# UNITED STATES PATENT AND TRADEMARK OFFICE

<b>Office Action Summary</b>	Application No. 09/745,780	Applicant(s) ROBERTS ET AL.	
	Examiner W. David Coleman	Art Unit 2823

## **DETAILED ACTION**

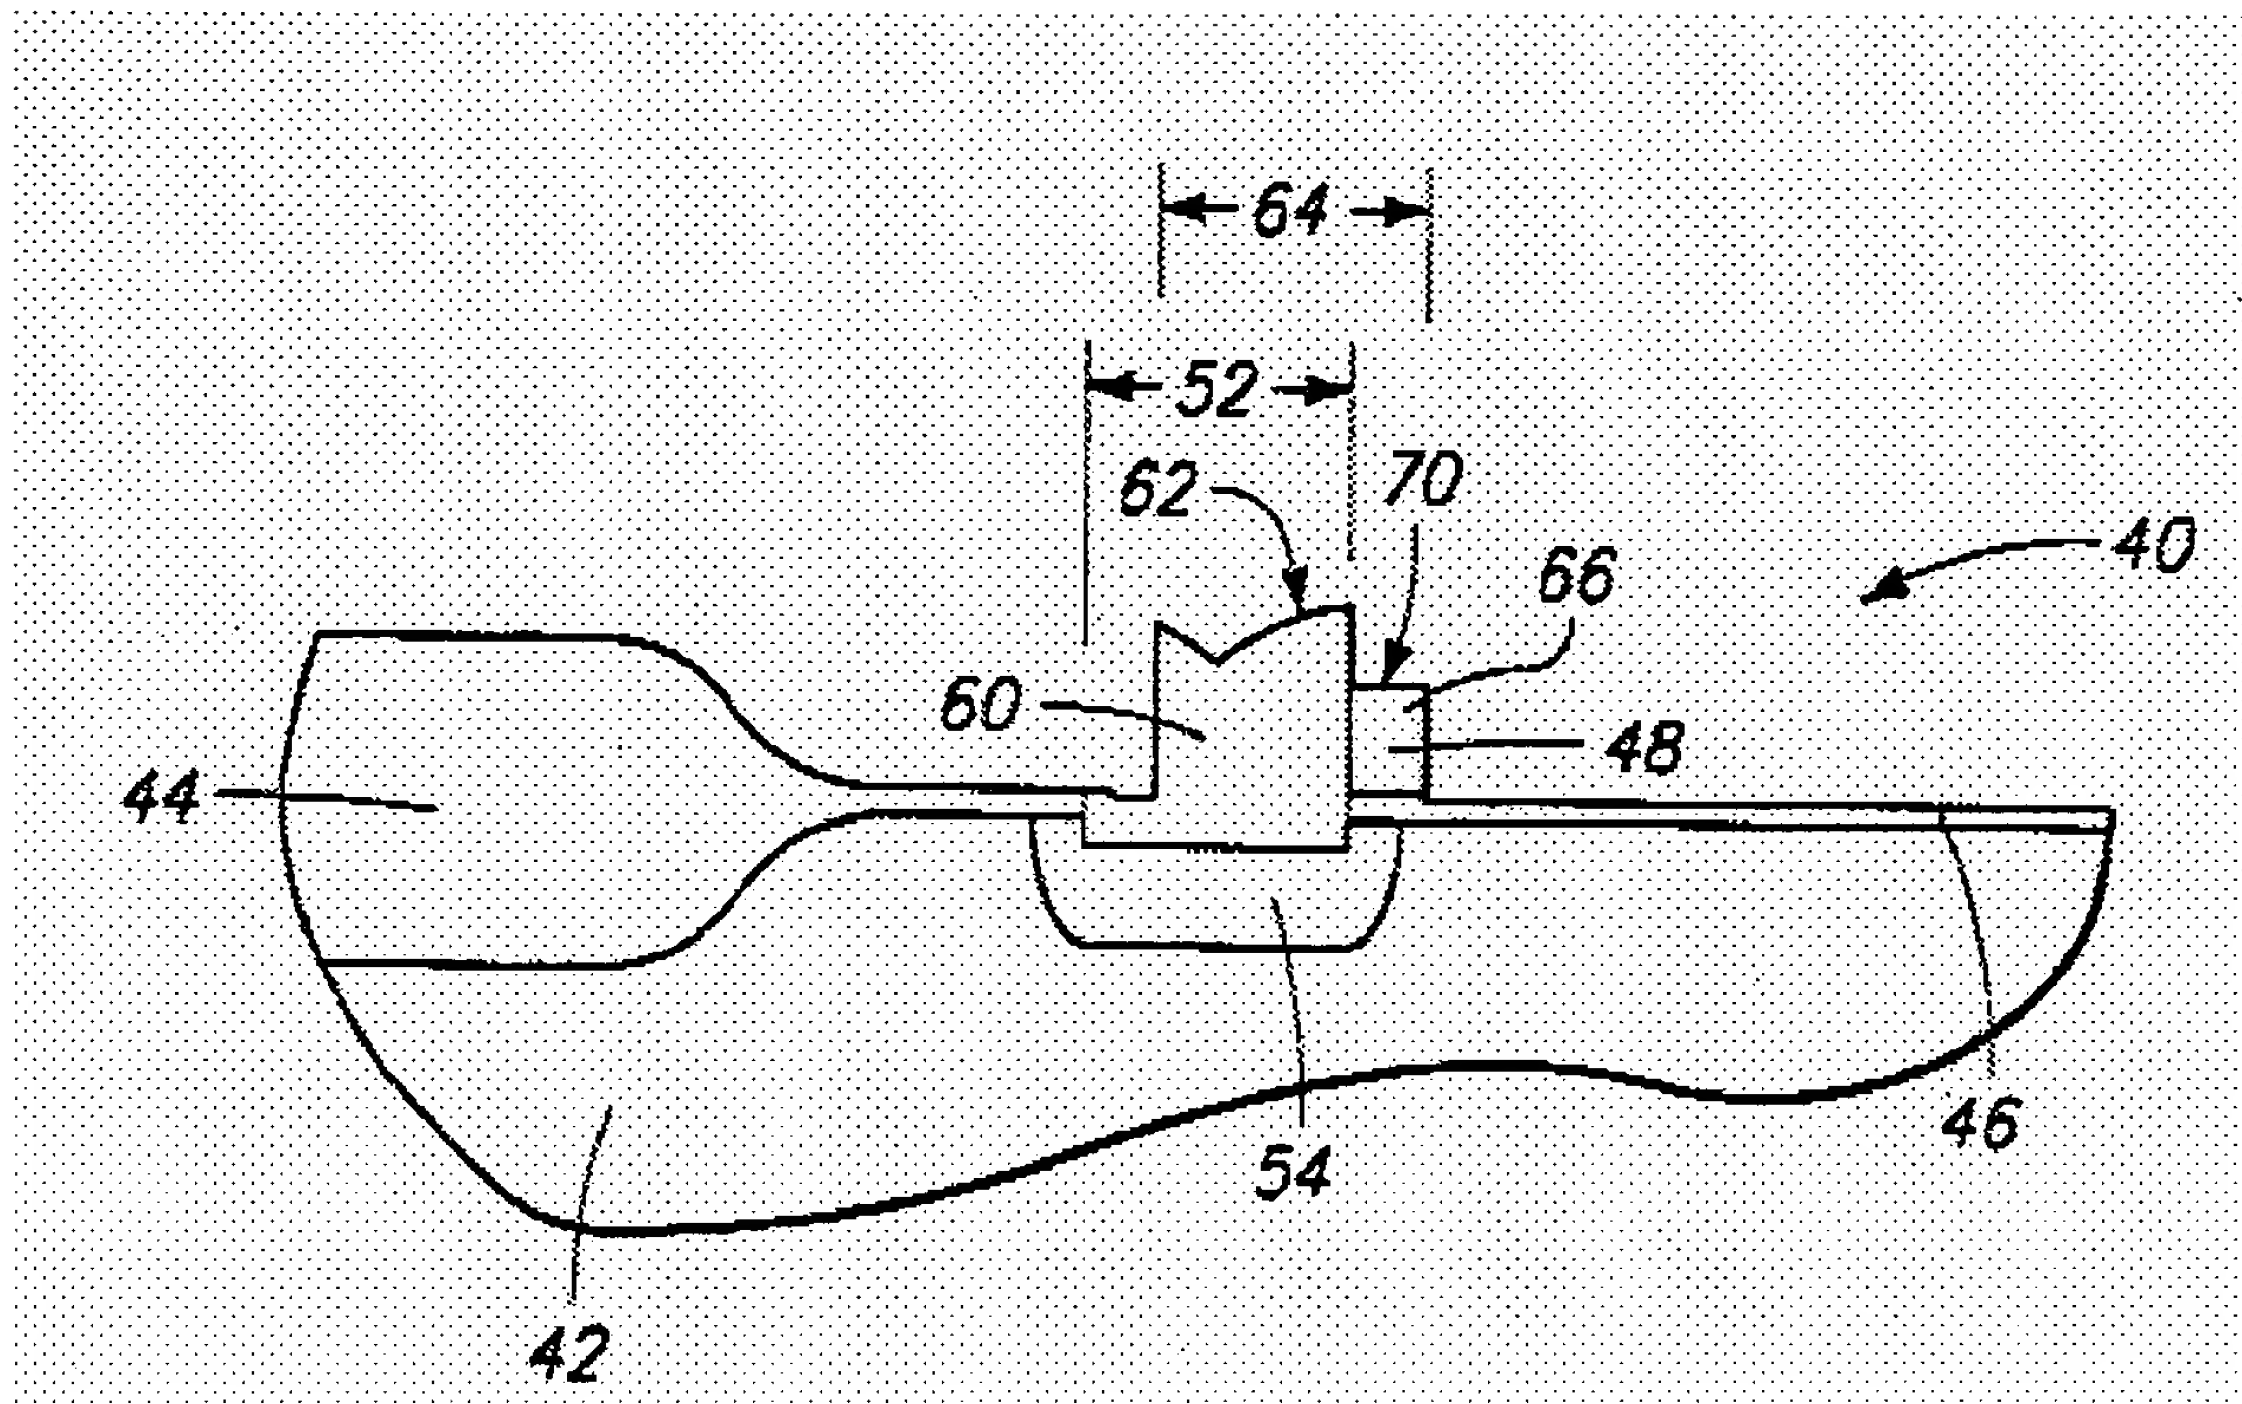
Applicant contends that claim 38 is distinguishable from Tang because claim 38 calls for particular relationship between the thickness of the oxide layer and the height of the first poly layer that is shown in the cited Tang patent:

“a first polycrystalline silicon layer overlying the oxide region but not the first substrate region having a thickness selected such that a lowest upper surface of the first polycrystalline silicon layer is higher than a highest upper surface of the oxide region.

Applicants further contend that Tang shows a structure where the first poly layer 48 has its lowest upper surface either lower than or at a height about equal to the highest upper surface of oxide region 44.

In response to Applicants contention that Tang fails to show the claimed limitations as pertaining to claim 38 please see FIG. 9 where Tang teaches the claimed limitation. It appears that Applicants are relying on the features of oxide 44, whereas the Examiner is relying on first polysilicon 48/66 where the lower portion of the polysilicon is above oxide layer 46. Applicants arguments are moot.
